Engineering Change Notification

Introduction of new ATEX module connectors and wall brackets.

Project No
240562

Date
16.02.2022

Example: MS4-MV-EX

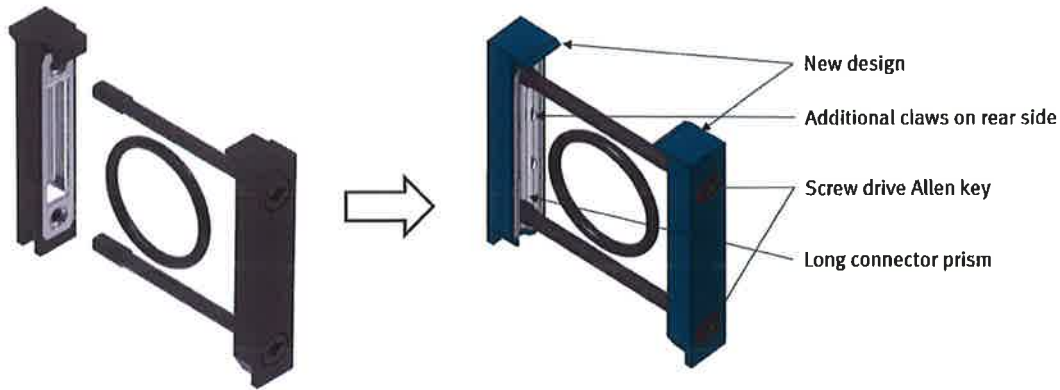
Slightly different dimensions and new screw heads.

Existing MS4-MV-EX	New MS4-MV-EX
Dimension module connector: 8 x 41,8 x 8,2 mm	Dimension module connector: 8 x 43,2 x 8,7 mm
Screw length : 38,3 mm	Screw length : 42,7 mm
Screw head: Kombi-TORX 10	Screw head: Hexagon socket 2
